Modification of rating mark

Change of rated current acc. to UL 60320

1681 Appliance Inlet					0118.2196	
creation date	created by	release date	released by	notification no.	revision	page
2014-01-06	helbljio	2014-02-11	hotzar	25633	-	1 of 2

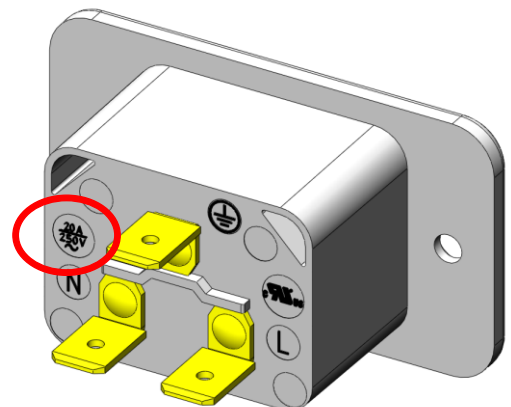
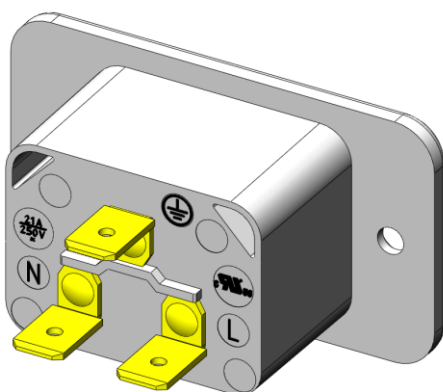
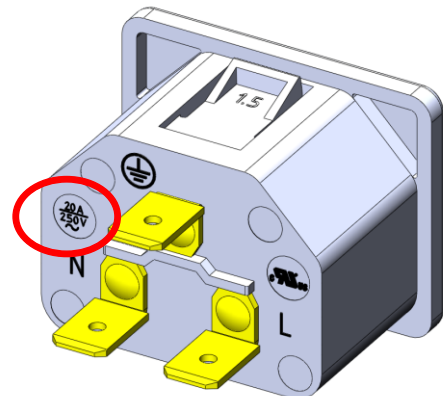
Old marking

New marking

Rated current adjusted to UL 60320

Form: New current rating according to UL 60320
Fit: N/A
Function: N/A
Production Site: N/A
Product Label: N/A
